**STATE OF TENNESSEE
DEPARTMENT OF TRANSPORTATION**

Re: ADDENDUM #4
Contract No. DB1601
County: Maury

**State Route 396, Saturn Parkway Extension,
Maury County- TENNESSEE**

CONTRACT NUMBER: DB1601

TYPICAL SECTIONS

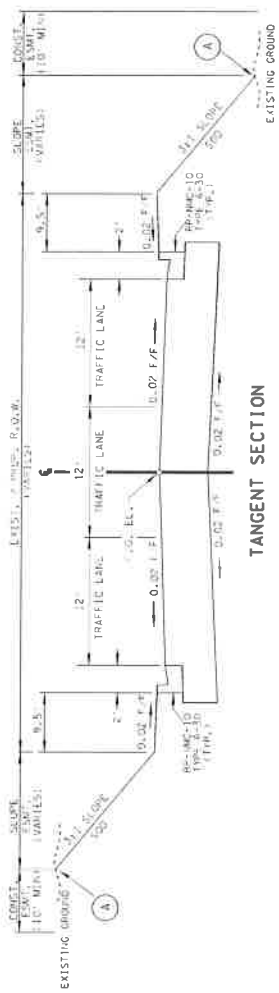
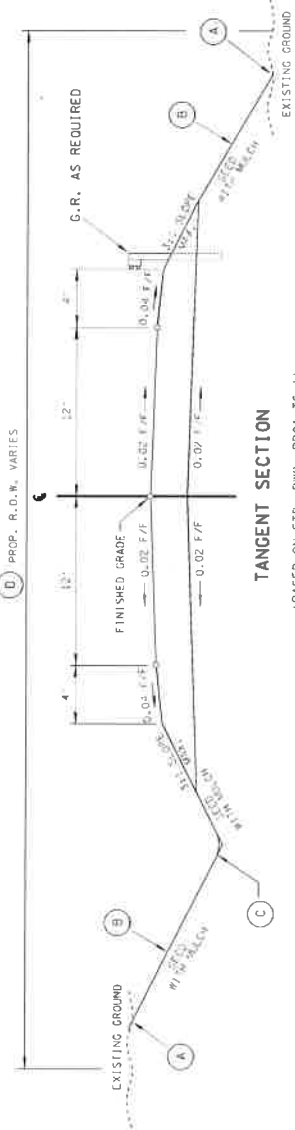
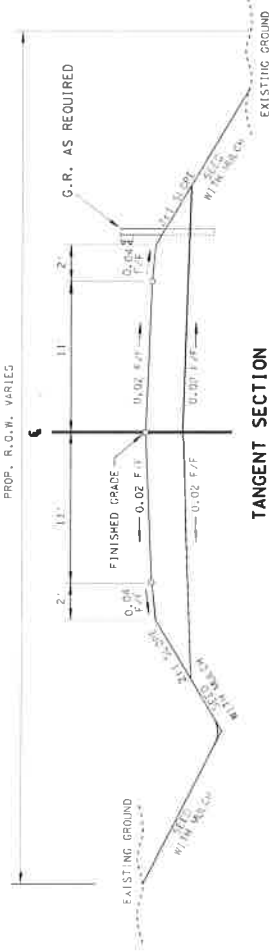
REV. 10-16-17: REVISED TYPICAL BRIDGE SECTION M-4. ADDED STIFF BRIDGE STABILIZATION TO TYPICAL SECTIONS. ADDED TEMPORARY DETOUR TYPICAL SECTION.

TANGENT BRIDGE SECTION SECTION B-B

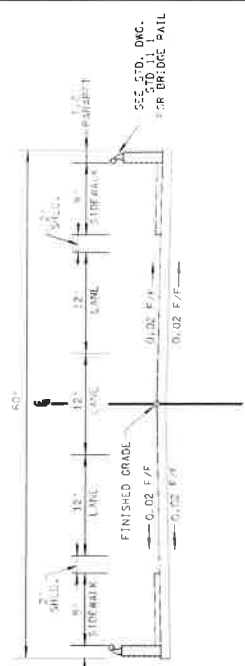
This addendum revises the RFP book 3, revises the typical bridge section b-b., adds slope Stabilization to typical sections, adds temporary detour typical section, and revises functional layout sheets (Figure 2 and 3 only) for the Saturn Parkway extension project which includes reduced structure width over CSX RR, and the addition of a field entrance across from the GM access road.

FIGURE 2
SATURN
PARKWAY
EXTENSION

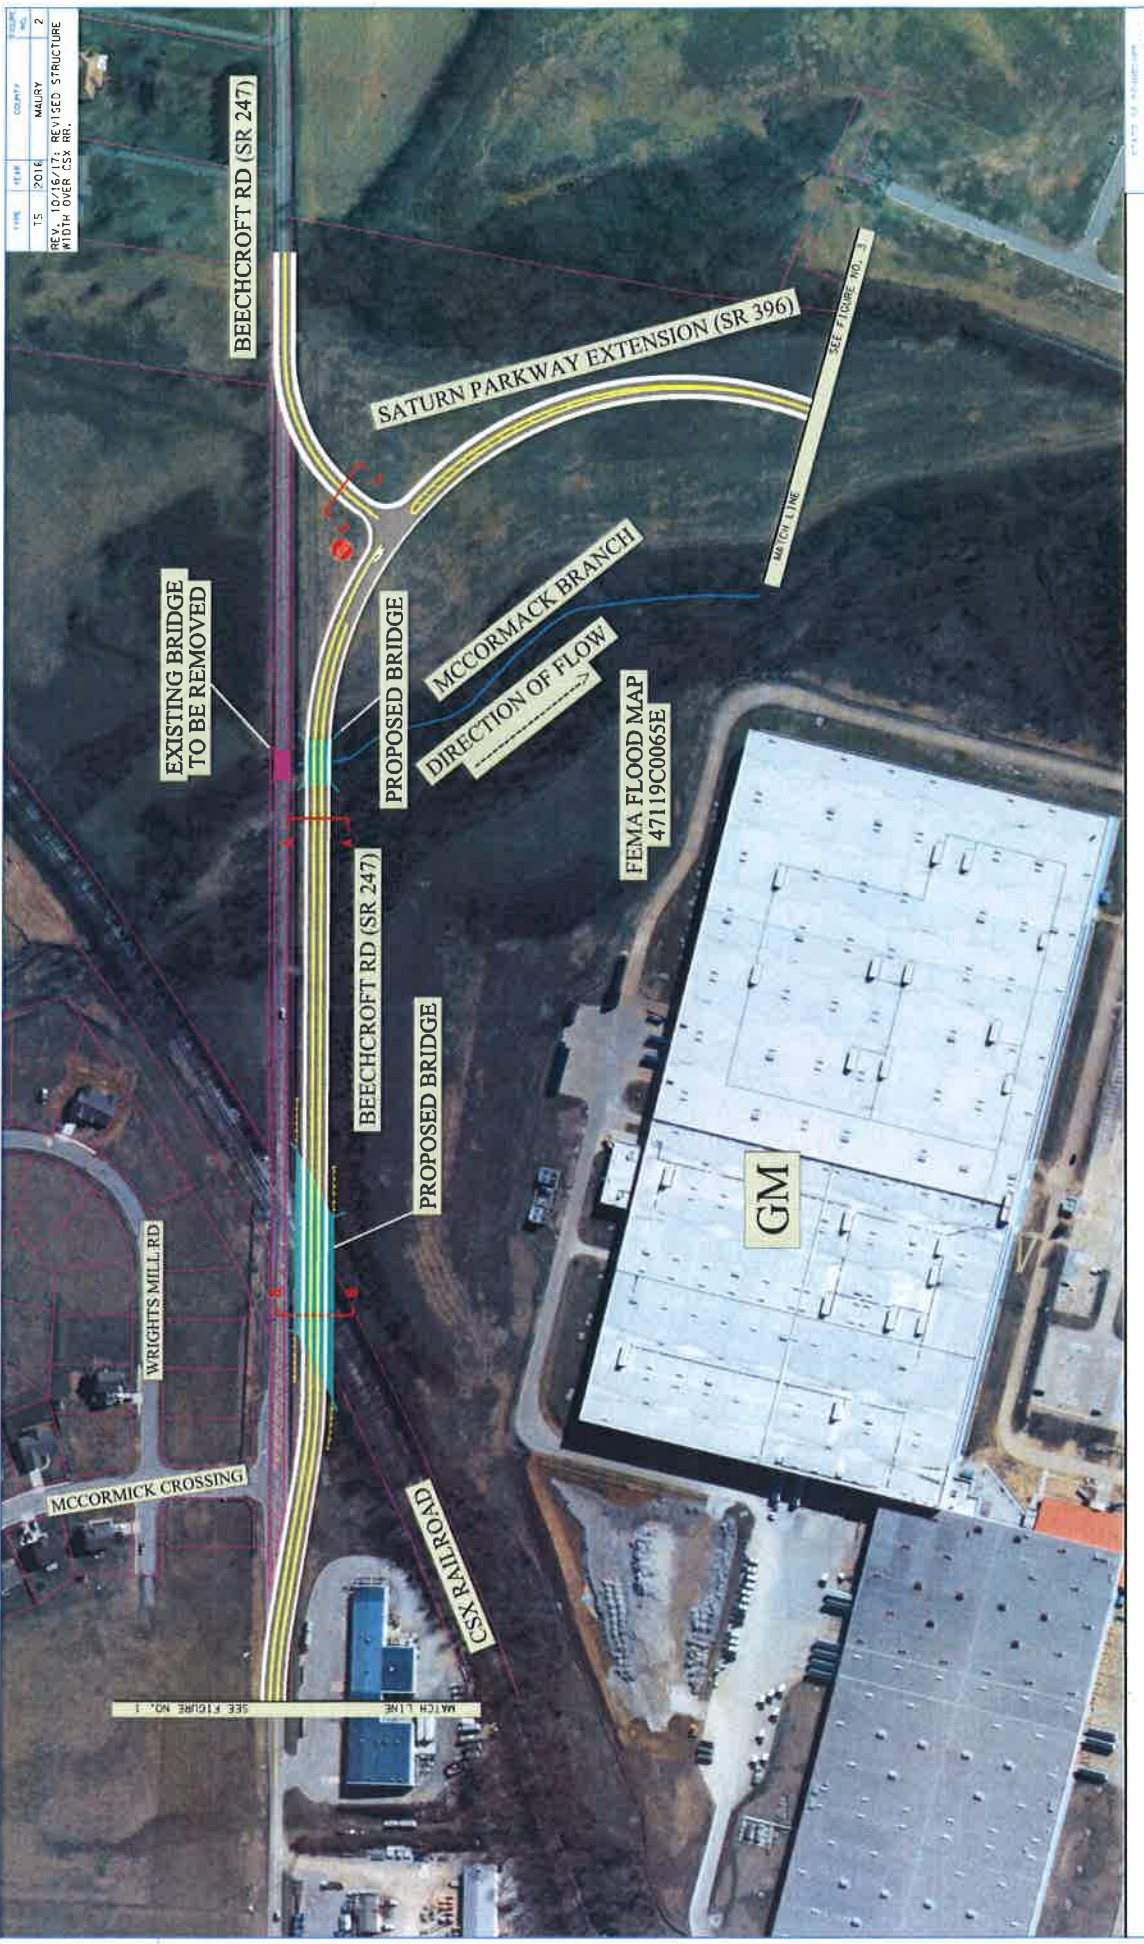
DATE	2016	COUNTY	MAURY
REV.	10/16/17	PROJECT	REVISSED STRUCTURE WIDTH OVER CSX RR.
